## HISTORIC AND DESIGN REVIEW COMMISSION

March 01, 2017

**HDRC CASE NO:** 2017-074  
**ADDRESS:** 415 FLORIDA ST  
**LEGAL DESCRIPTION:** NCB 3008 BLK 6 LOT 12  
**ZONING:** RM-4 H  
**CITY COUNCIL DIST.:** 1  
**DISTRICT:** Lavaca Historic District  
**APPLICANT:** Hayden Phillips  
**OWNER:** Haybevp, LLC  
**TYPE OF WORK:** Porch column replacement and front yard landscaping  
**REQUEST:**

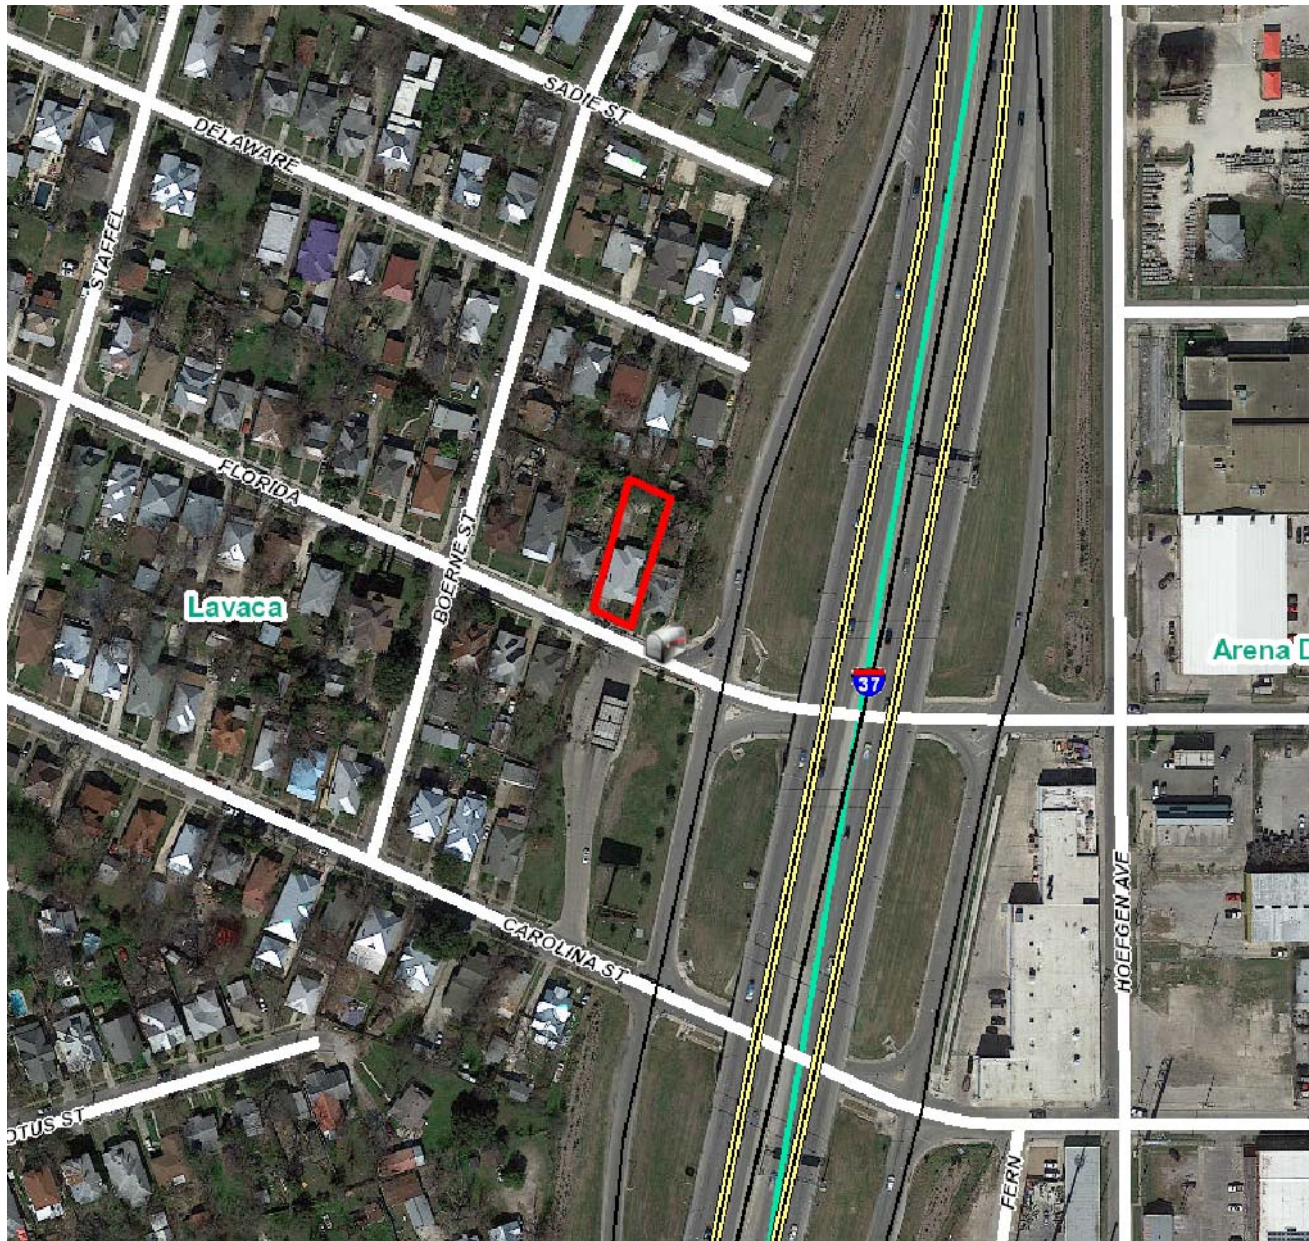
- a. The structure at 415 Florida was constructed circa 1910 and features Craftsman style elements, two brick chimneys, large roof overhangs and first appears on the 1912 Sanborn maps. The applicant has proposed to install architecturally appropriate front porch columns and perform landscaping to the front yard.
- b. COLUMN REPLACEMENT – The front porch currently features wrought iron columns that the applicant has

proposed to remove and replace with new wood columns that are to feature proportions and detailing with the Craftsman architecture style. The applicant has proposed to maintain the brick column plinths as they are. Per the Guidelines for Exterior Maintenance and Alterations 7.B.iii., replacement porch columns should be compatible in scale, massing and detail while materials should match in color, texture, dimensions and finish. The applicant's proposed columns are appropriate and are consistent with the Guidelines.

# PARTIAL SITE PLAN - DEMO

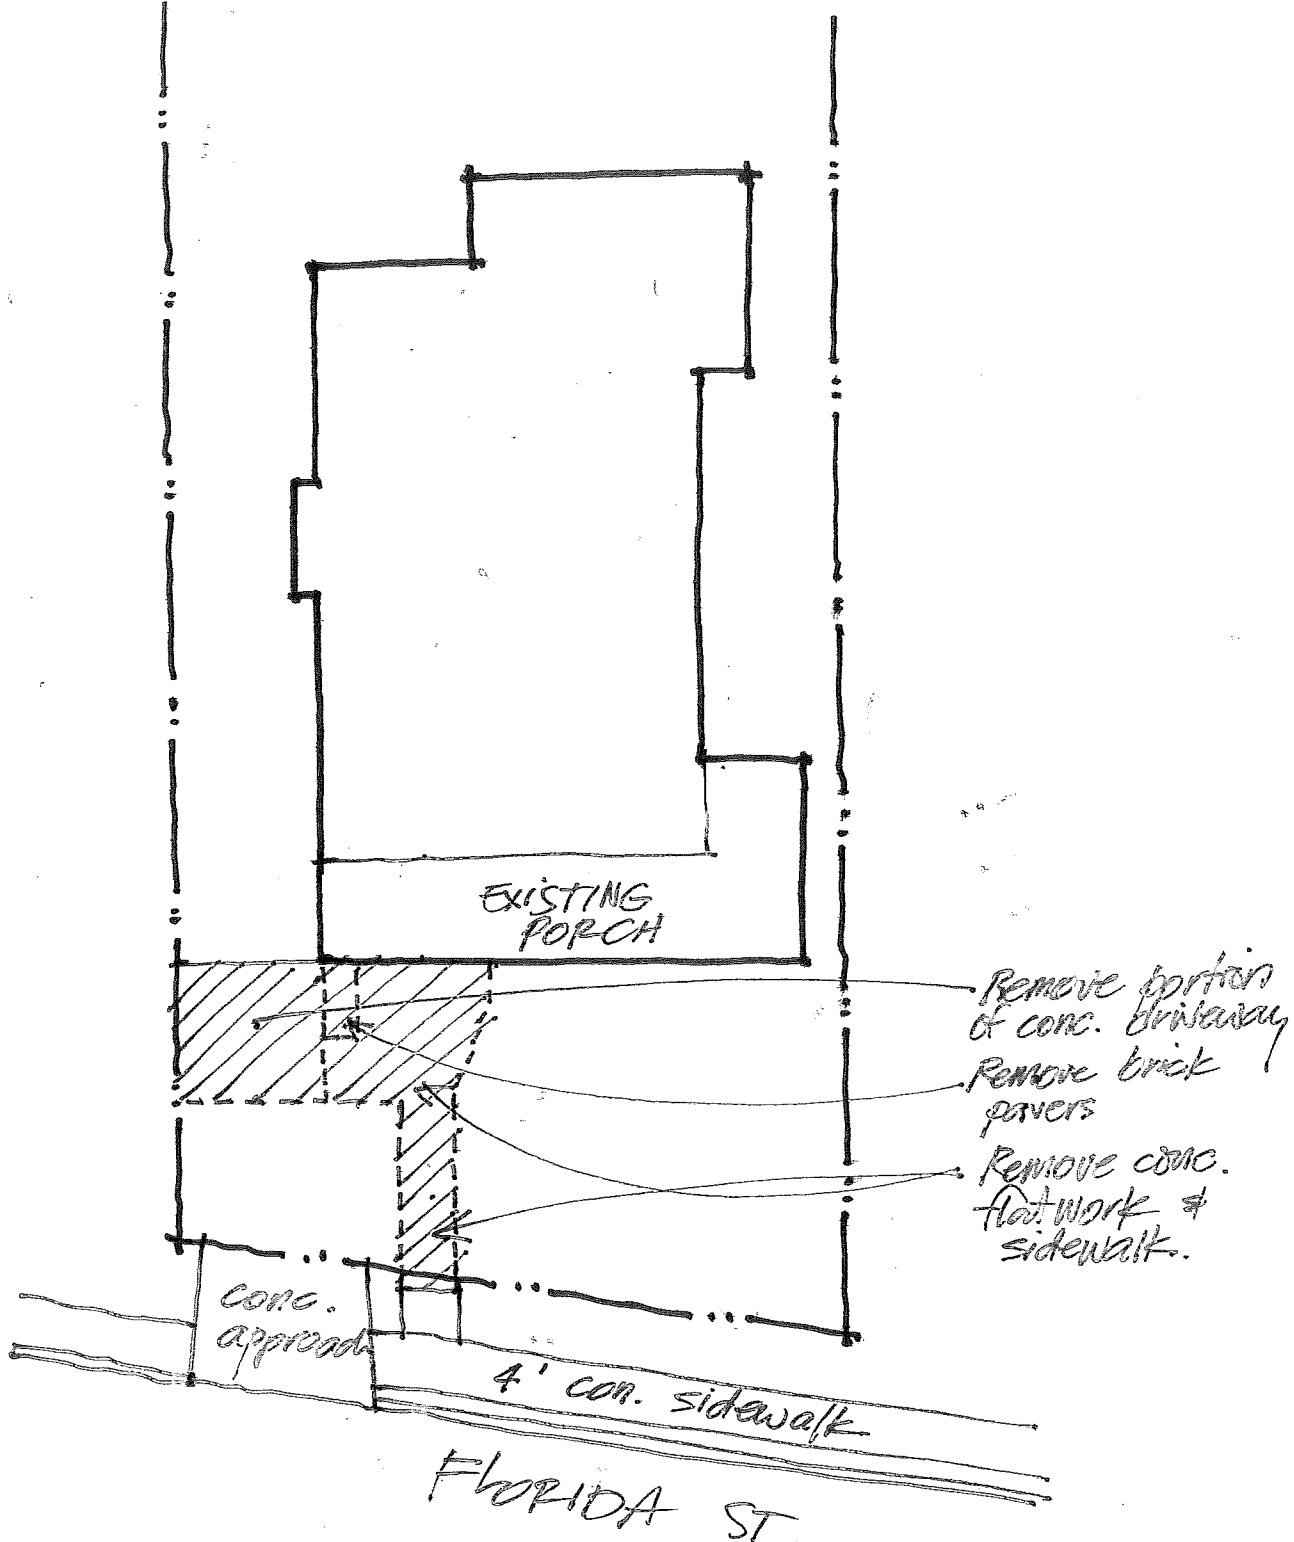
- c. **HARDSCAPING** – The front yard currently features a non-original front sidewalk and front yard paving which includes an atypical curb cut, a partial concrete driveway and a side yard concrete area that extends to the front of the historic structure. The applicant has proposed to remove the non-original concrete paving in the front yard to the front of the primary historic structure and install decomposed granite. The applicant has proposed to maintain the existing curb cut as well as the existing side yard concrete area. Staff finds this installation appropriate; however.

- The existing hardscape is a real hodge-podge of flatwork added in a piecemeal fashion through its history. The existing concrete walk from the public sidewalk is sloped in different directions due to soil conditions. Other flat work around the porch is very unattractive and disorganized. We propose to remove most of the flatwork as indicated on the marked-up photo attached, and replace with a more organized, attractive pervious hardscape, increasing the pervious cover, and a more xeriscape landscape design. See site plan sketch. The new walk pathway to the house would be segmented concrete pavers with crushed granite in between and re-designing the planting beds as indicated. The materials used would be:

# PARTIAL SITE PLAN

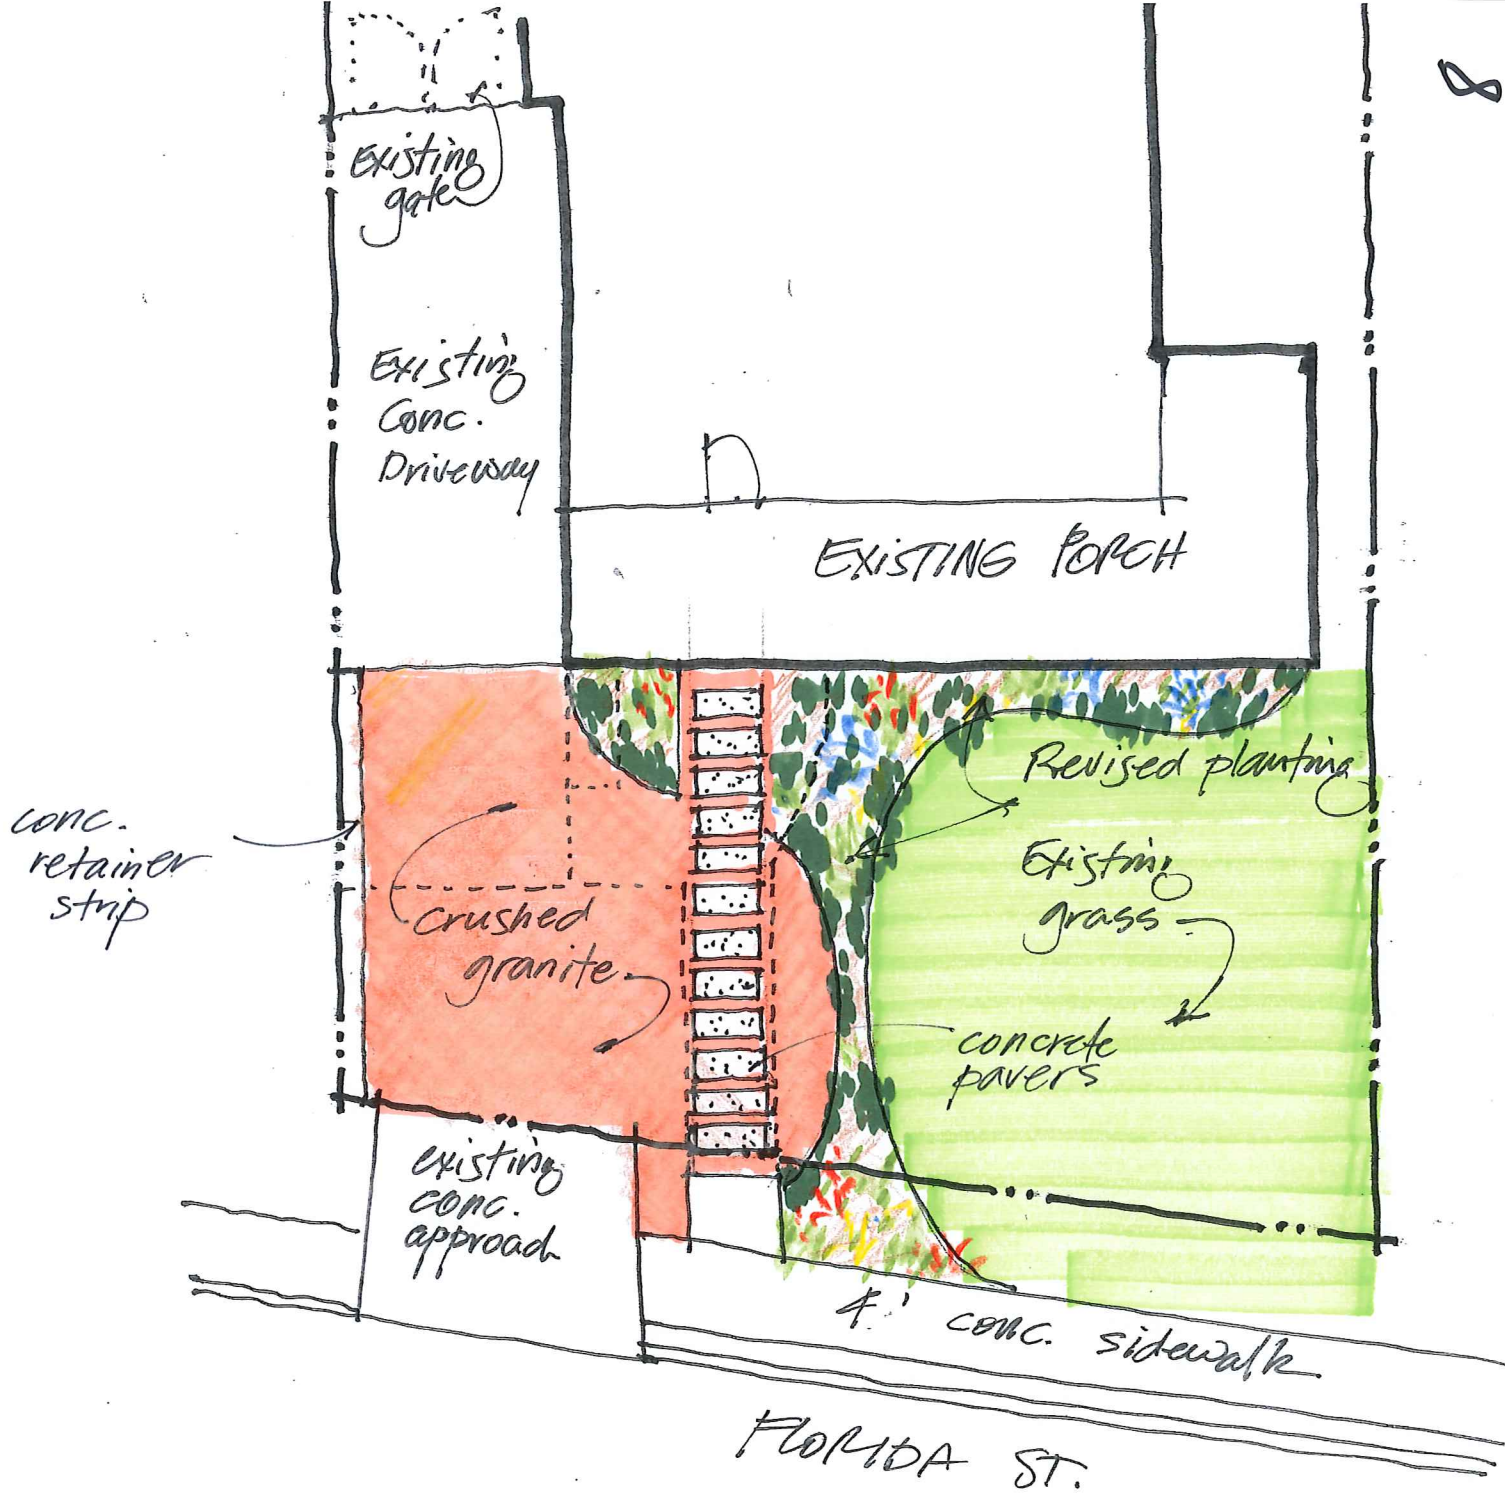
- d. **FRONT WALK** – The existing front walk has been modified and partially removed from its original configuration. The applicant has proposed to remove the existing front walk area and install concrete pavers that maintain the location and general width of the existing sidewalk as well as those sidewalks located on Florida. This is consistent with the Guidelines for Site Elements 5.A.iii.

- e. **LANDSCAPING** – The applicant has proposed to install various native plants including red yucca, lantana, Mexican feather grass, salvia, rosemary, Mexican bush sage and fall aster. The applicant has proposed to maintain half of the existing front yard area that is currently covered by grass. This is consistent with the Guidelines for Site Elements 3.A.ii.

- a. Granite pebbles
  - b. Decomposed granite
  - c. Precast concrete pavers (approximately 18" x 36")
  - d. Planting combination of Red yucca, lantana, Mexican feather grass, salvia, rosemary, Mexican bush sage, and fall aster, etc., to provide a variety of color and texture.

# COLUMN DETAIL

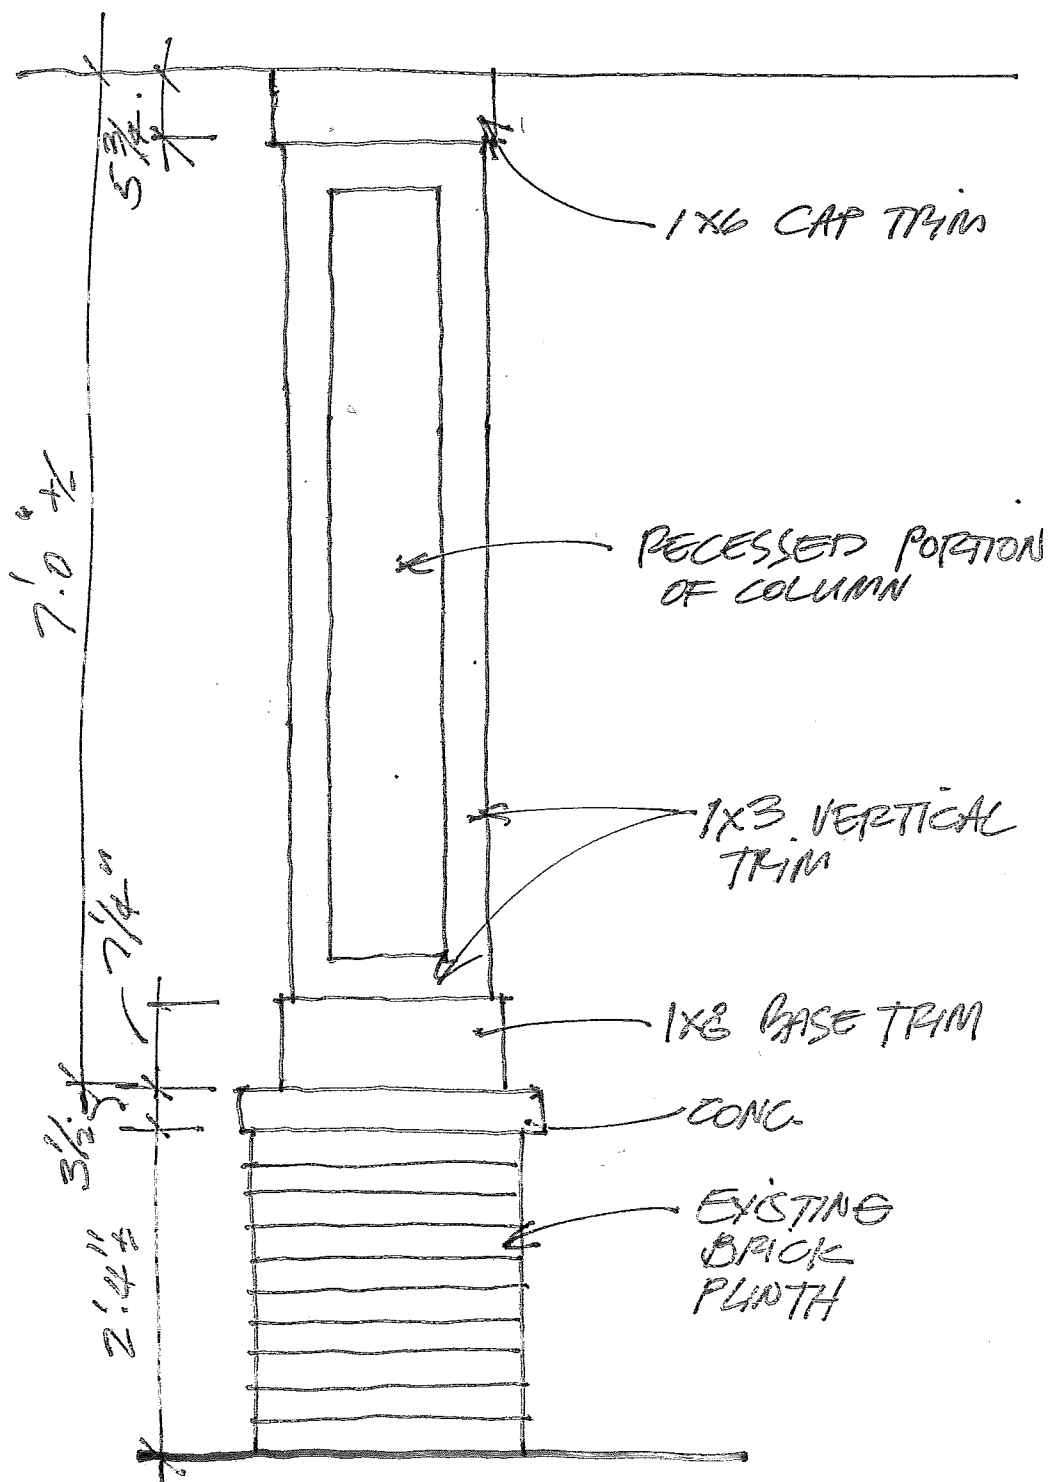
- Construct new boxed columns on top of the existing brick/concrete plinths in place of the current decorative steel columns. The proposed columns will be appropriately proportioned and trimmed out to emulate more of a Craftsman Era style befitting of this 1930's home. The materials used will be smooth boards, primed and painted white. See existing exterior photo, sketch and detail attached.
